BOWMANS CREEK WIND FARM

SUBMISSIONS REPORT

for Epuron Projects Pty Ltd

8 October 2021

FIGURE 7

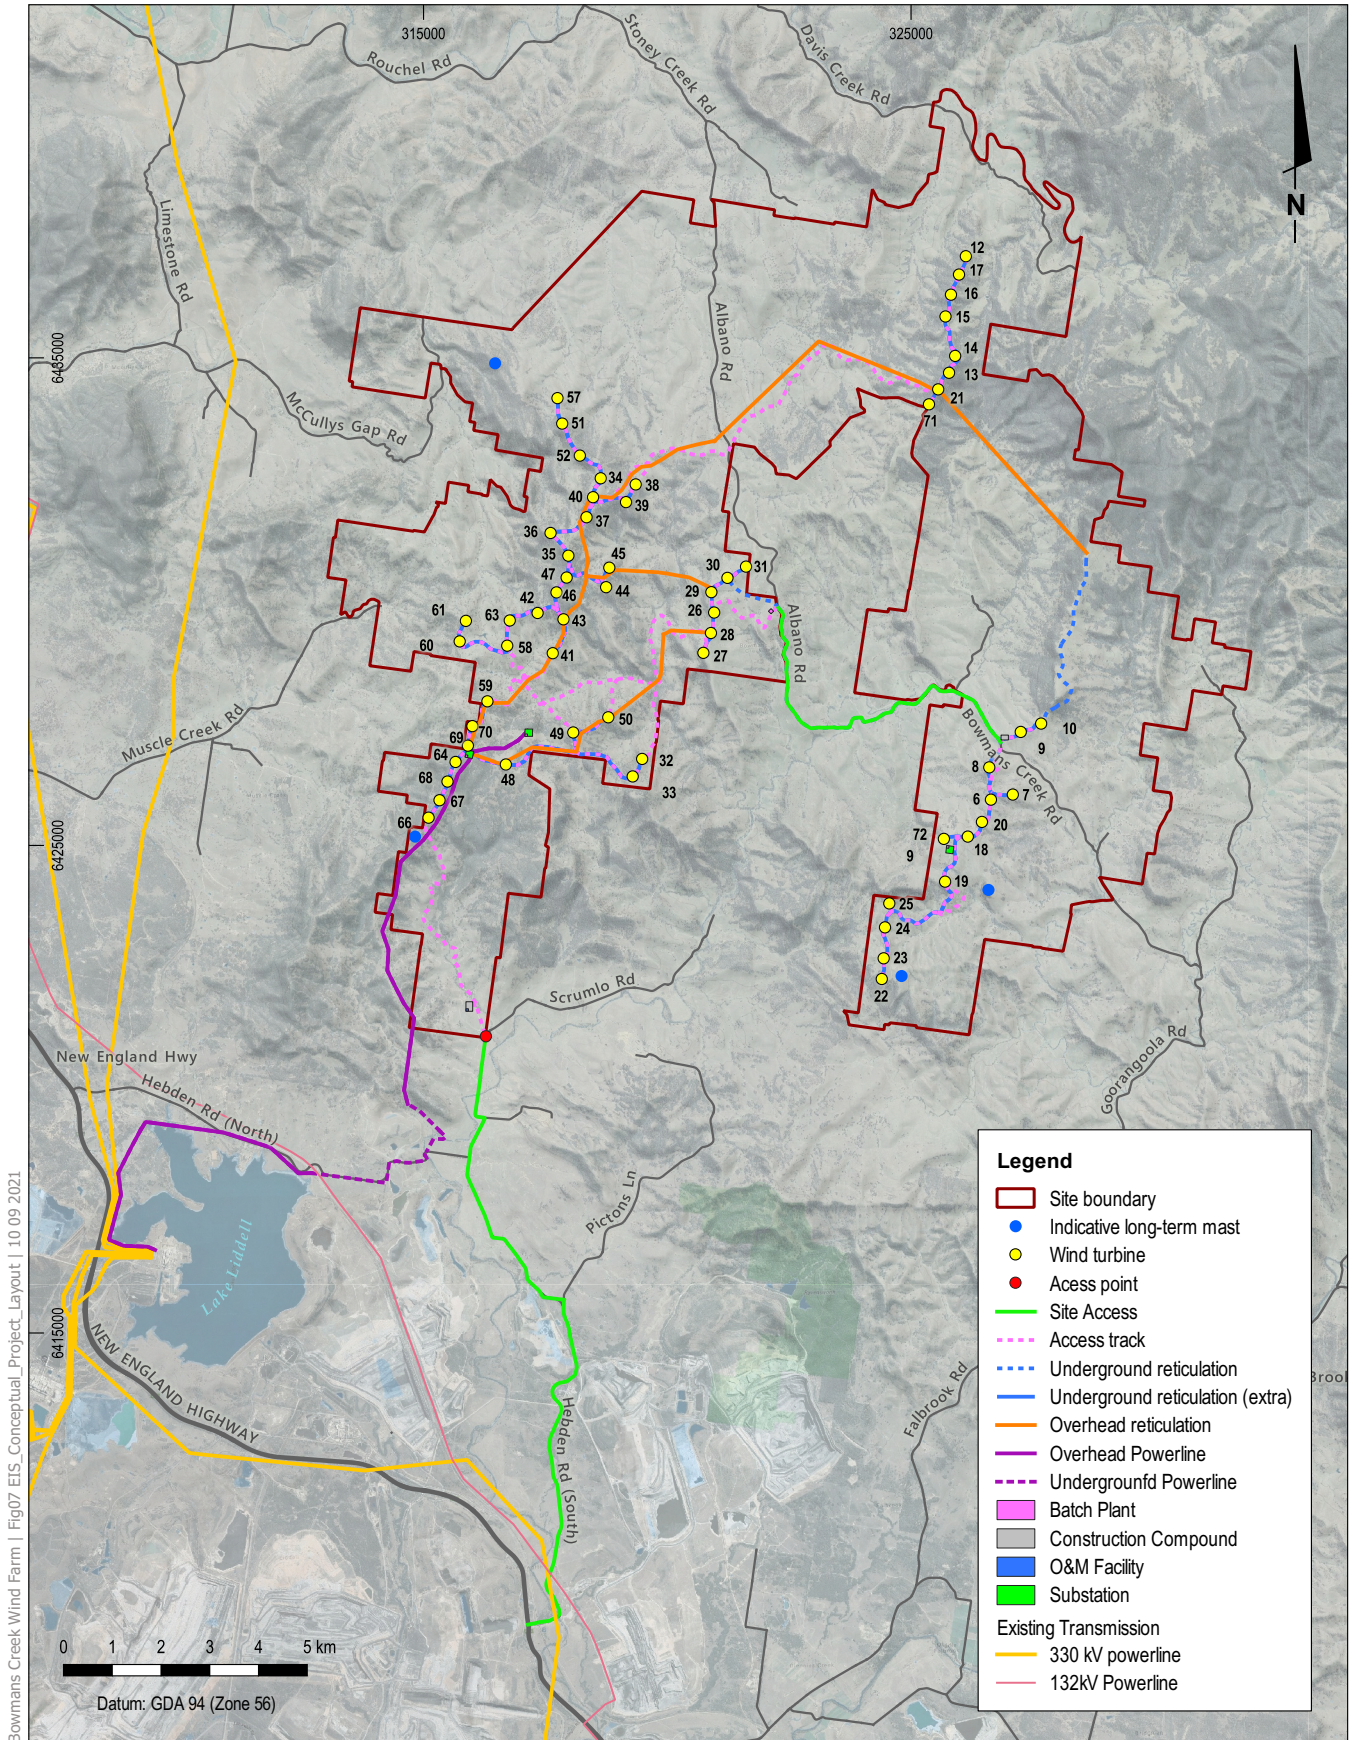
SC has requested the LGA boundaries be added to Figure 3 in the EIS Main Text.

Figure 3 of the EIS has been updated with the proposed refinements to the Project and to include the Council LGA boundaries (refer to **Figure 7**). This amended figure is also included in the updated Project Description of the Amendment Report.

FIGURE 9

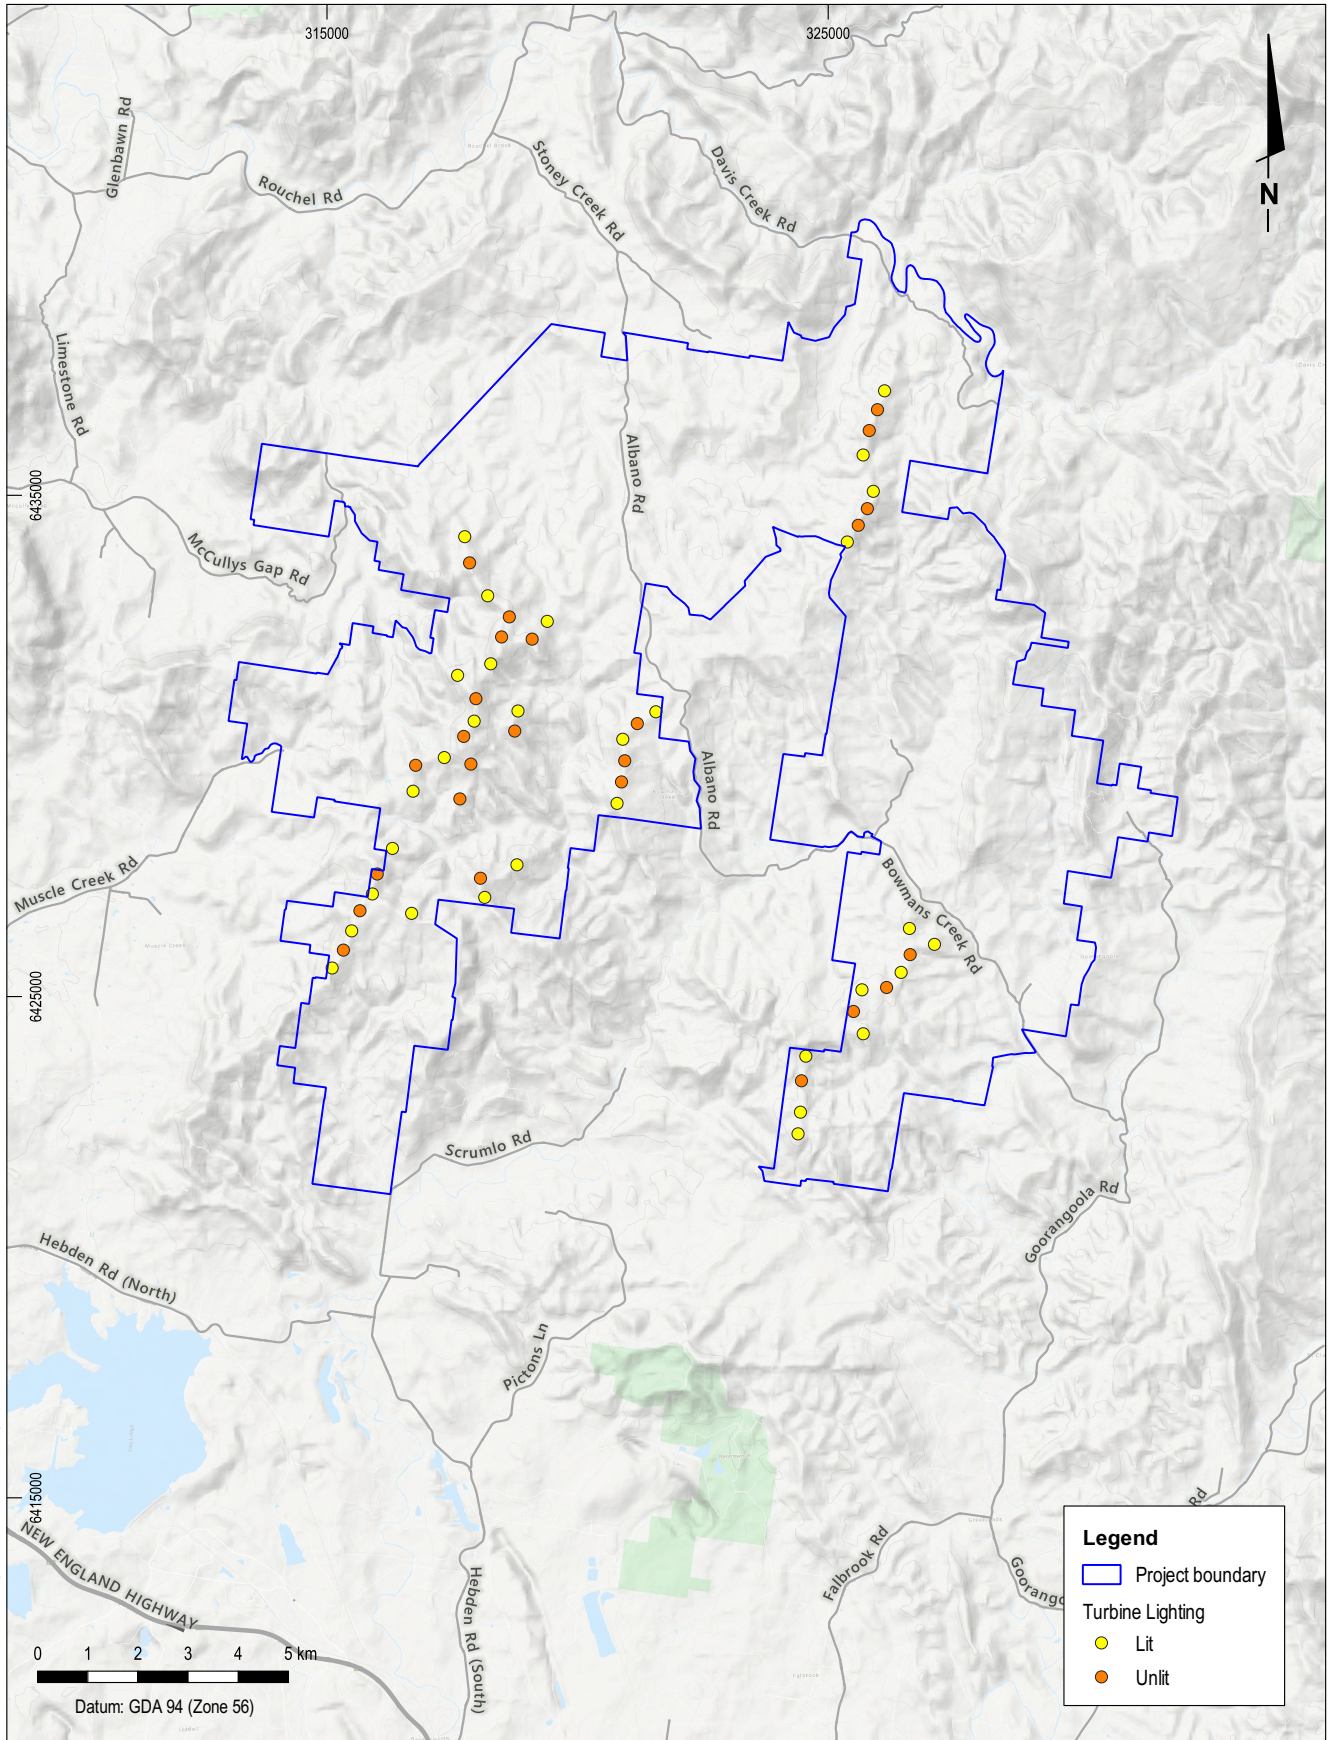
CASA considers the risks to aviation safety could be mitigated to some extent by the provision of obstacle lighting and recommends that the wind farm is obstacle lit with medium intensity steady red lighting in accordance with the National Airports Safeguarding Framework Guideline D and section 9.31 of the CASA Part 139 (Aerodromes) Manual of Standards.

The Proponent has written to CASA to request whether low intensity can be considered as an alternative. A draft wind turbine lighting plan has also been provided to CASA for review. The draft lighting plan identified 31 of the 56 wind turbine locations to be lit. Refer **Figure 9** for details.

FIGURE 10

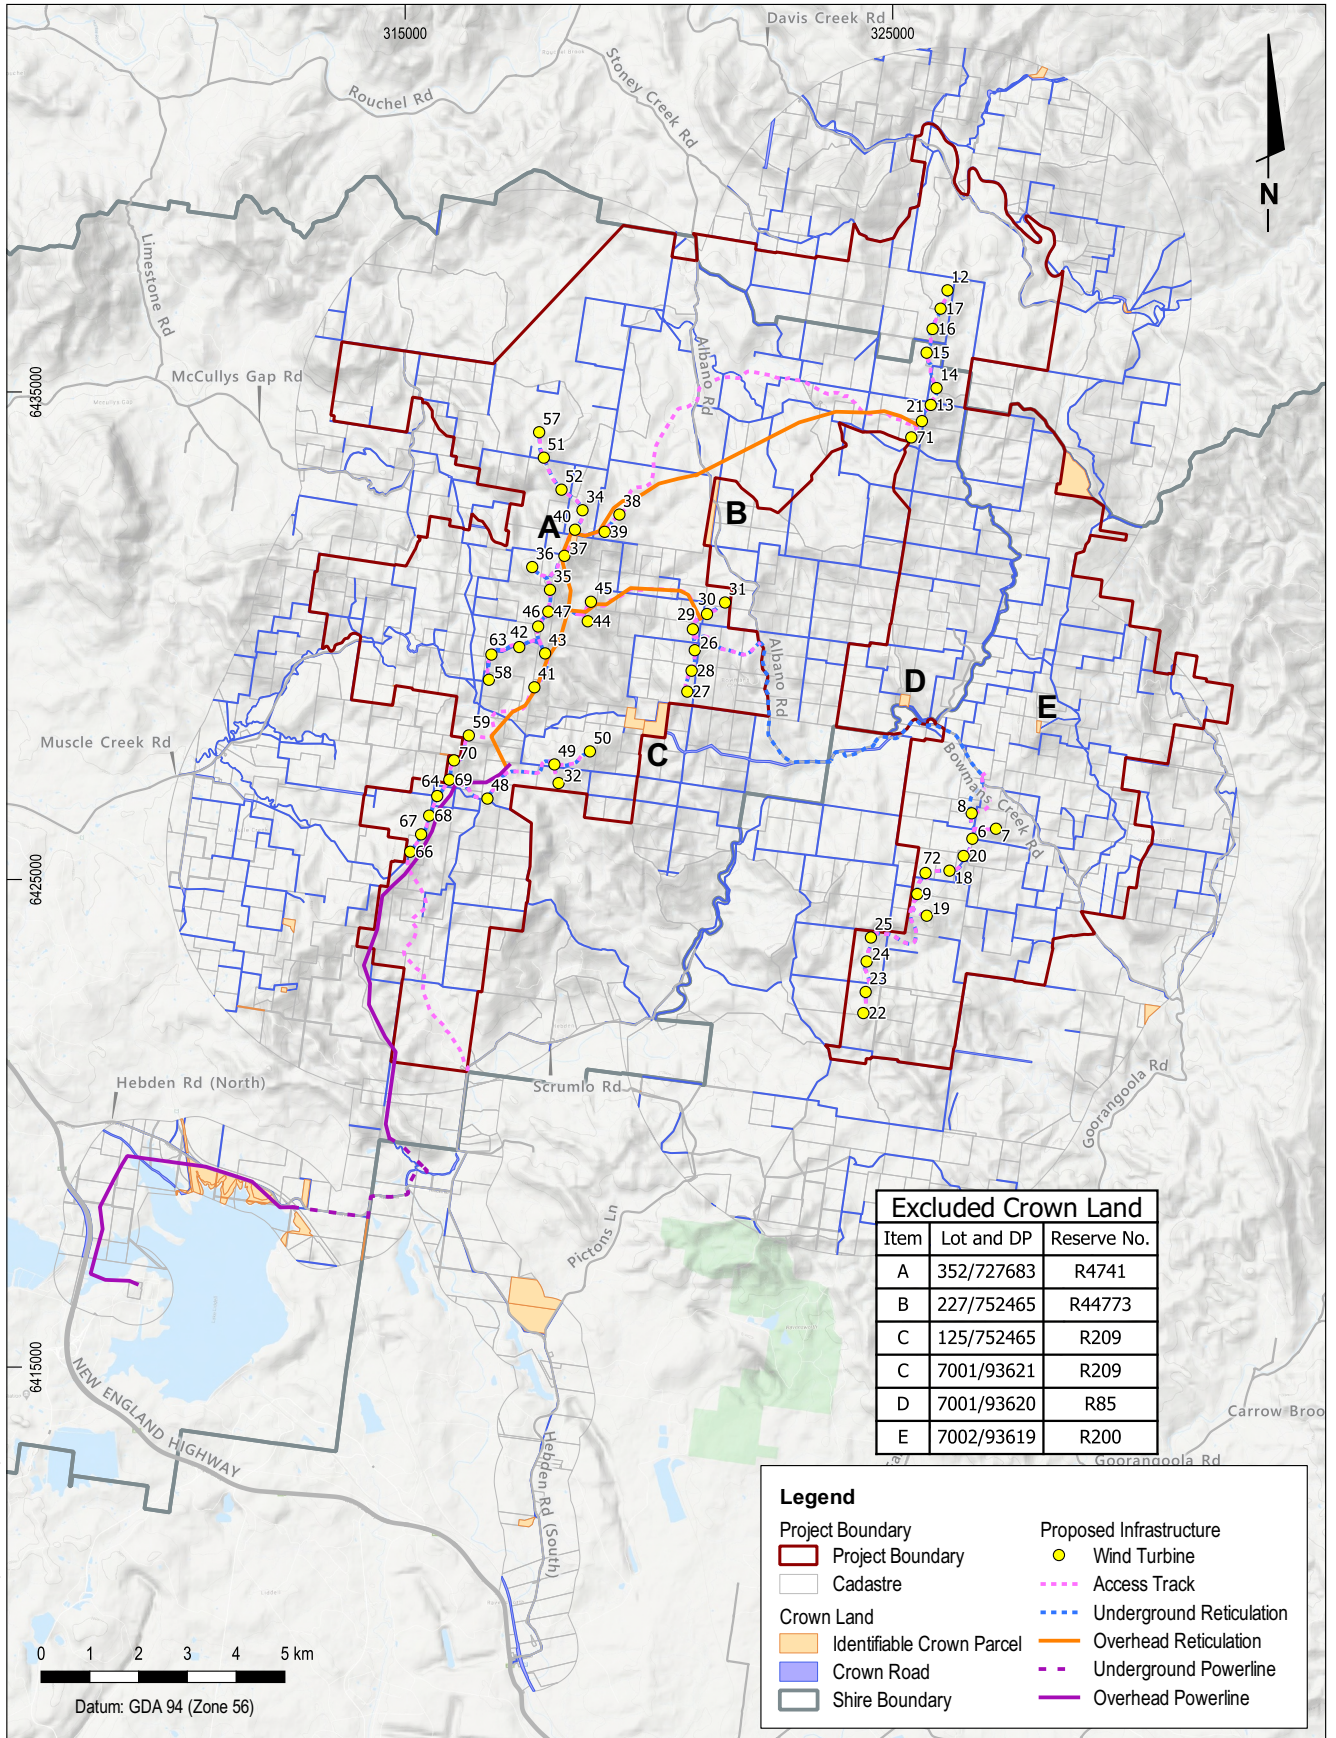
2. Lot 227 DP 752465, being Reserve 44773 gazetted on 19 January 1910 for Camping and Travelling Stock. This reserve is under the care, control and management of the Hunter Local Land Services (LLS). This parcel is subject to undetermined ALC 42926 lodged on 23 January 2017 by the Wanaruah Local Aboriginal Land Council. Page 81 of the EIS states that "the reserve will not be impacted by access tracks or site access associated with the Project". However, Figure 26, on Page 82 of the EIS, shows the reserve traversed by both "site access" and "access track".

- Evidence of concurrence from the Wanaruah Local Aboriginal Land Council regarding use of any Crown land subject to Aboriginal Land Claims. More information on Aboriginal Land Claims can be found here <https://www.industry.nsw.gov.au/lands/what-we-do/our-work/aboriginal-land-claims>.

- A native title assessment for use of the affected Crown land noting that the Department cannot deal in land until native title under the Native Title Act 1993 (Cth) has been resolved. The Department cannot endorse dealing in (leasing or licensing) of any Crown parcel that is subject to unresolved native title issues. More information on Native Title and Crown land can be found here <https://www.industry.nsw.gov.au/lands/what-we-do/our-work/native-title>.

The Proponent reconfirms that Reserve 44773 will not be directly impacted by site access tracks. It is only the gazetted public road that intersects Reserve 44773 that will be relied upon for access from one side of the reserve to the other. Figure 26, on Page 82 of the EIS shows an access track immediately to the northwest of this parcel of land, not crossing the land. This is illustrated on **Figure 10** below.

The Proponent has redesigned access such that any Crown Land subject to an Aboriginal Land Claim has been avoided. See **Figure 10**.

The Proponent has redesigned access such that any Crown Land subject to Native Title is avoided (see **Figure 10**).
